Project	<b>IEEE 802.16 Broadband Wireless Access Working Group</b> < <a href="http://ieee802.org/16">http://ieee802.org/16</a> >	
Title	<b>Proposed changes to section 8 of the Draft IEEE 802.16m System Description Document</b>	
Date Submitted	<b>2008-05-02</b>	
Source(s)	Yair Bourlas, Lei Wang NextWave Wireless Inc.	Voice: E-mail: <a href="mailto:ybourlas@nextwave.com">ybourlas@nextwave.com</a>
Re:	Comments on the IEEE 802.16m-08/003r1 SDD draft – Section 8	
Abstract	802.16m Air-interface protocol structure is described in terms of 16e MAC architecture. We believe that section 8 should be a complete description of the 16m air interface.	
Purpose	Call for comments for IEEE 802.16m meeting in Macao	
Notice	<i>This document does not represent the agreed views of the IEEE 802.16 Working Group or any of its subgroups. It represents only the views of the participants listed in the “Source(s)” field above. It is offered as a basis for discussion. It is not binding on the contributor(s), who reserve(s) the right to add, amend or withdraw material contained herein.</i>

## Proposed changes to Section 8 of the SDD

Figure 1 The IEEE 802.16m Protocol Structure

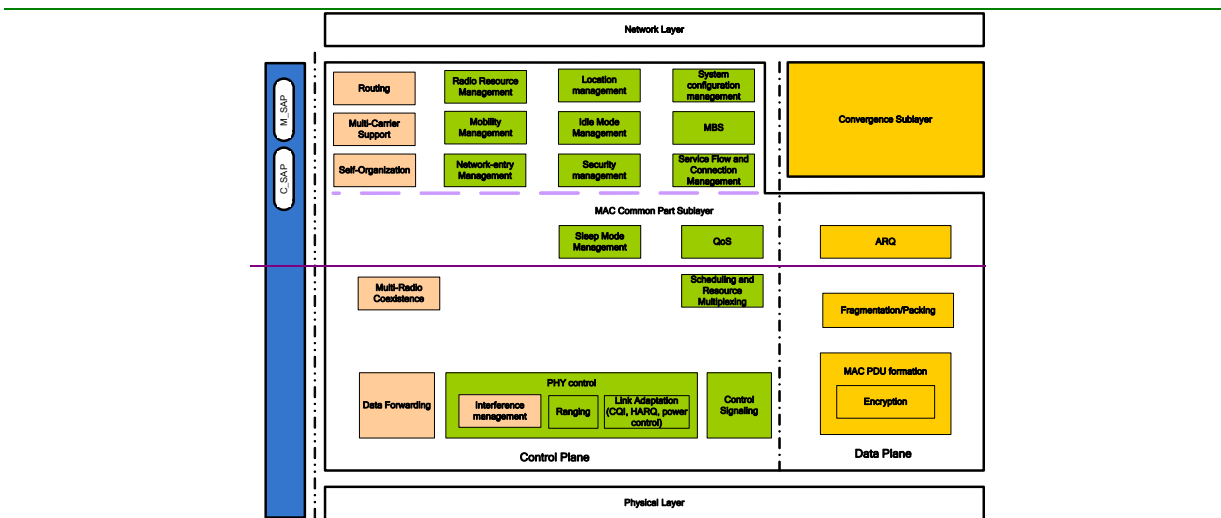
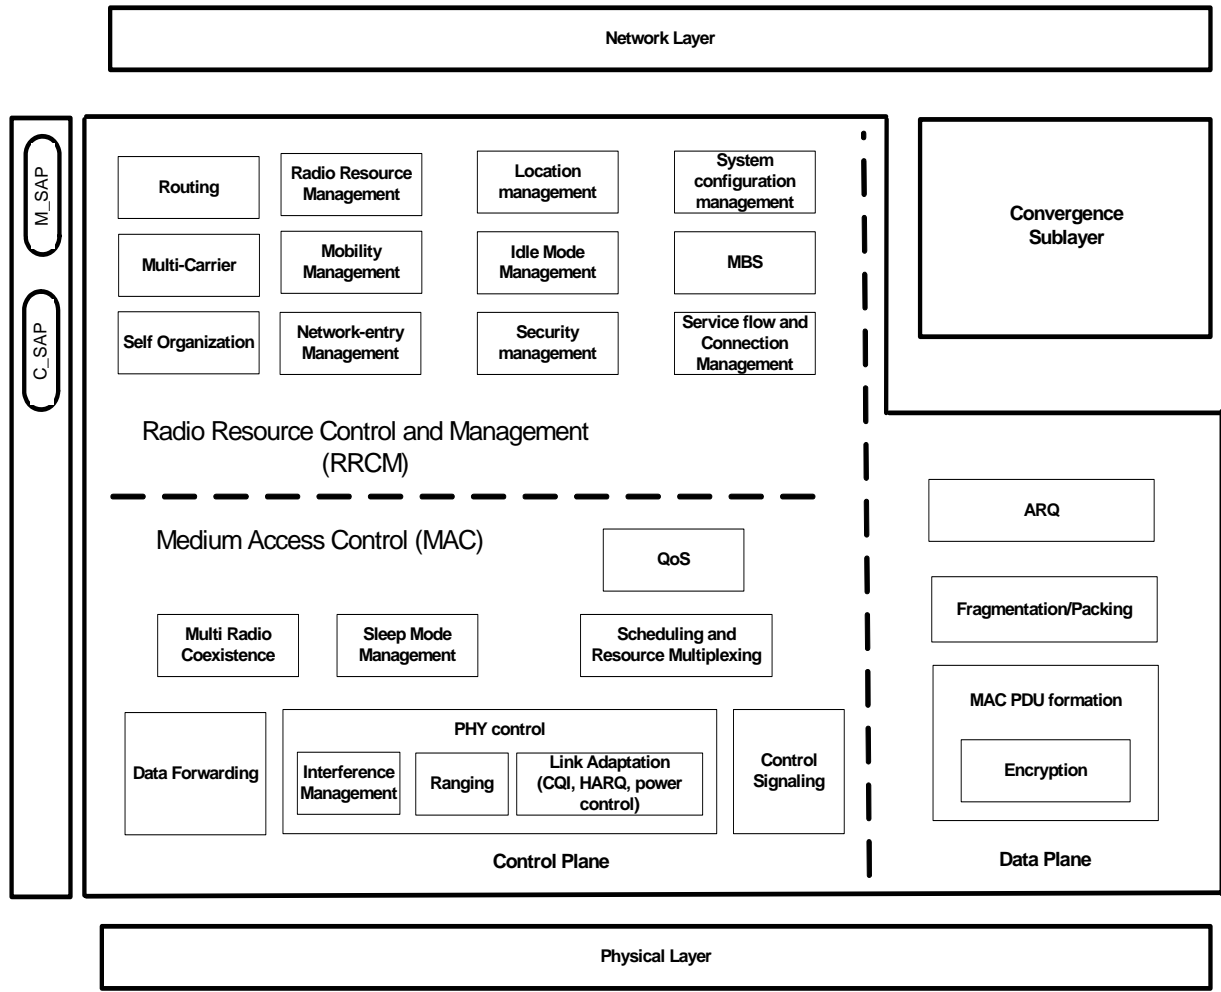
The IEEE 802.16m RRCM includes several functional blocks that are related with radio resource functions such as follows the MAC architecture of current IEEE 802.16e and includes additional functional blocks for 802.16m specific features (see Figure 4). The following additional functional blocks are included:

- Radio Resource Management
- Mobility Management
- Network-entry Management
- Location Management
- Idle Mode Management
- Security Management
- System Configuration Management
- MBS
- Connection Management
- Routing
- Self Organization
- Multi-Carrier
- ~~Multi-Radio Coexistence~~
- ~~Data forwarding~~
- ~~Interference Management~~
- ~~Inter-BS coordination~~

- 25 • PHY Control
- 26 • Control Signaling
- 27 • Sleep Mode Management
- 28 • QoS
- 29 • Scheduling and Resource and Multiplexing
- 30 • ARQ
- 31 • Fragmentation/Packing
- 32 • MAC PDU formation
- 33 • Multi-Radio Coexistence
- 34 • Data forwarding
- 35 • Interference Management
- 36 • Inter-BS coordination
